Product Correction

Model 3120 ZOOM Programmers

WAND #: 090701-WAND-671KBE

Subject: Continued use of older Model 2868 TY+ software on Model 3120 ZOOM™ programmers to support transvenous CRT-Ds and ICDs until supply chain constraints on newer programmers¹ are resolved. (Boston Scientific Field Action Reference: 92822246-FA).

Figure 2. Message that displays when a Boston Scientific TV defibrillator is interrogated by a 3120 ZOOM programmer if 2868 TY+ software is uninstalled.

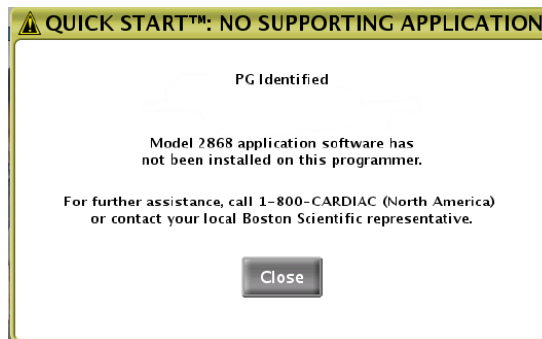
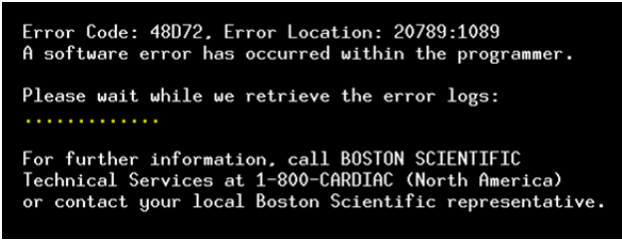
As part of this software upgrade, product labeling was updated to direct users to avoid using outdated 2868 software and Boston Scientific began uninstalling this software from 3120 ZOOM programmers. Soon after, Boston Scientific became aware of the likelihood of pandemic-induced global supply chain constraints on 3300 LATITUDE programmer supply and discontinued the uninstallation process in most regions because there could be insufficient programmers to support implanted TV defibrillators. When 2868 software is uninstalled, the 3120 ZOOM programmer can no longer interrogate TV defibrillators. If a user attempts to interrogate a device without applicable software, a message is displayed (Figure 2) to notify the user that software has not been installed on the programmer. To determine if a programmer has 2868 software, select “About” on the programmer screen and review the list of software applications installed. Please note that, 2868 software is the only outdated application on the 3120 ZOOM programmer.

The behaviour most likely to be attributed to potential harm when using a 3120 ZOOM programmer is the inability to interrogate a TV defibrillator (e.g., Figure 2 or 3). There have been 9 reports of this behaviour which have resulted in a delayed/prolonged procedure until the defibrillator can be interrogated with a 3300 LATITUDE programmer. Furthermore, there has been a single report of delays in reprogramming for phrenic nerve stimulation and a single report of an inability to interrogate for delivery of commanded therapy. None of the reports associated with 3120 ZOOM programmer have resulted in permanent injury.

- 1) If unable to interrogate a TV defibrillator with a 3120 ZOOM programmer, use a 3300 LATITUDE programmer instead. If this behaviour occurs, STAT PACE, STAT SHOCK, and DIVERT THERAPY programmer operations are not available through a 3120 ZOOM programmer, so external pacing/defibrillation or magnet application (to divert shock) may be required if a 3300 LATITUDE programmer is not immediately available.
